MAYFLOWER PLATINUM

Details of Additions & Alterations

Flat No	404	Block no.	'B'
Flat Area	1800 sft	Type	Deluxe / Luxury ✓
Buyer Name	P. RAMESH		
Phone No.	8500651963 9848420163	Email	pramesh8@hotmail.com.

Description	Direction	Owners & Developers :	Date :	06.08.2020	Promoted by
WORKING DRAWING OF FLAT.NO.B-4		Modi Properties Pvt Ltd.	Prepared By :		Modi Properties Pvt. Ltd Phone:+91-40-66335551
		Project Name & Phase :	Approved By :	Soham Modi	
		MAYFLOWR PLATINUM	Scale :	N.T.S

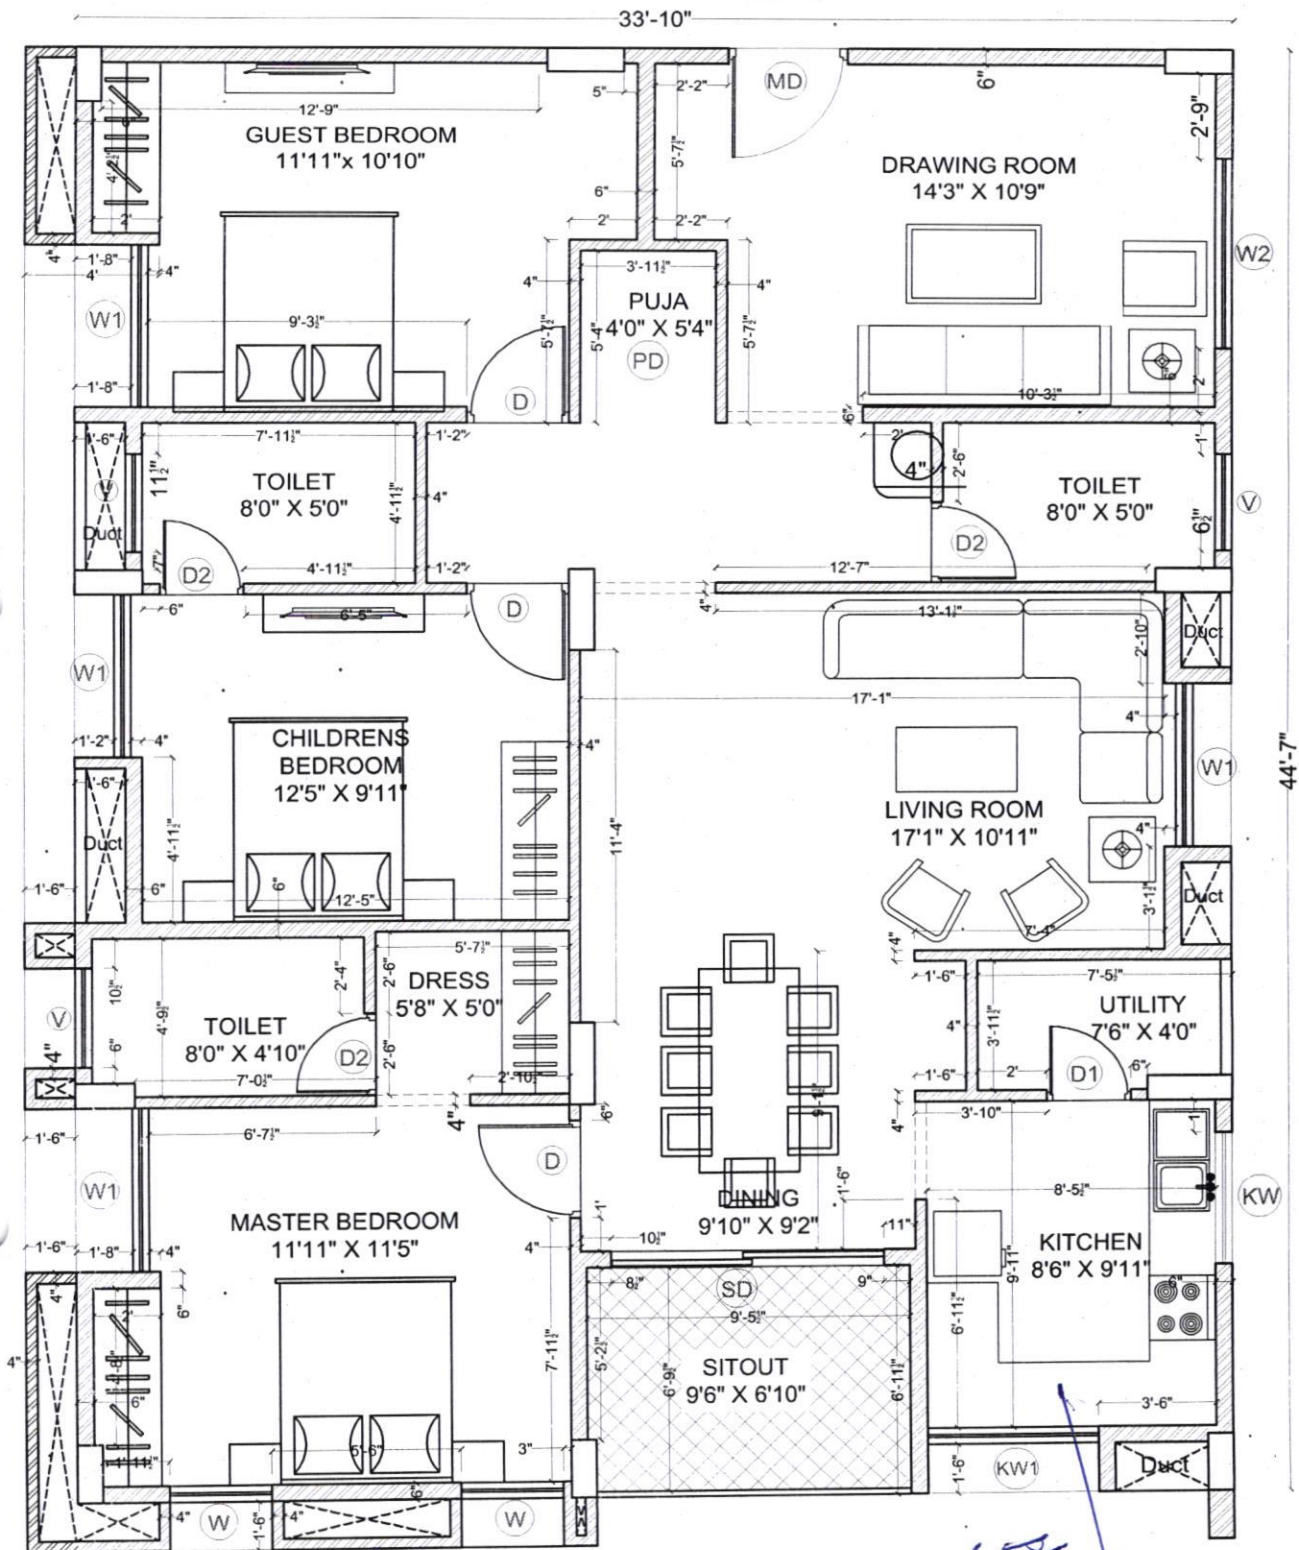
1) Kitchen platform to be 'U' shape as marked.

⇒ Granite platform to be provided with patti at edge.

⇒ Modular kitchen units to be both on Sitout wall
(kitchen west wall).

6'6" square.
Kitchner to be same as default.

Description	Flat No	06/08/2021	Prepared By:	Modi Properties & Investments Pvt. Ltd.
	Owners & Project Name		Approved By:	Soham Modi
ELECTRICAL PLAN OF FLAT-B4	Project Name & Phase:	Mayflower Grande	Scale:	N.T.S

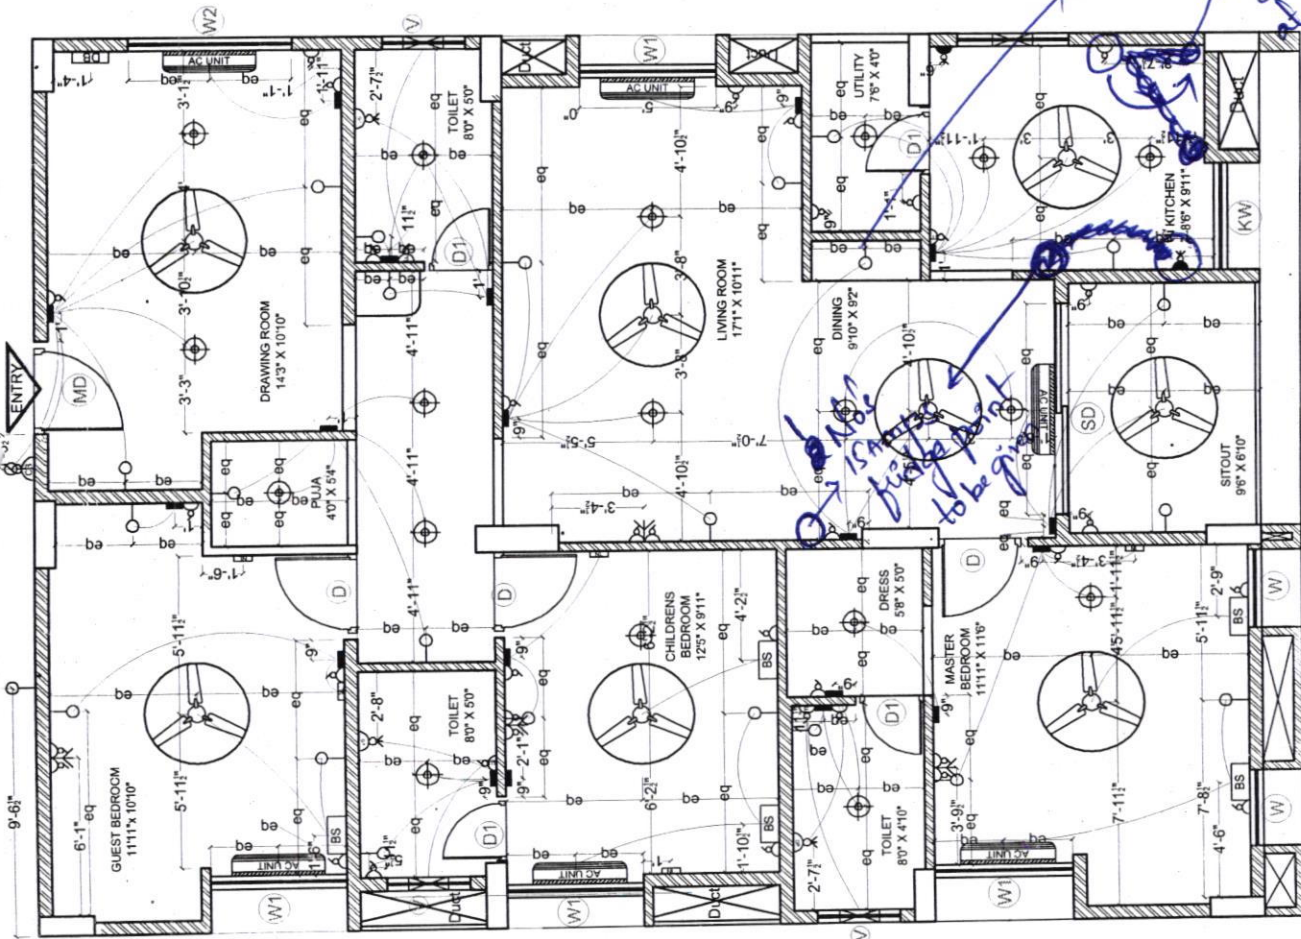
- 1) 15amps point to be given in living room @ controller as marked
- 2) Extra 15amps to be given in kitchen at wall edge.
- 3) Switch point at Stove to be moved ^{to corner wall as marked} ~~to corner wall as marked~~ ^{as marked} ~~as marked~~ beside window as marked at dado height.
- 4) Wall light at dining Wash basin as default.
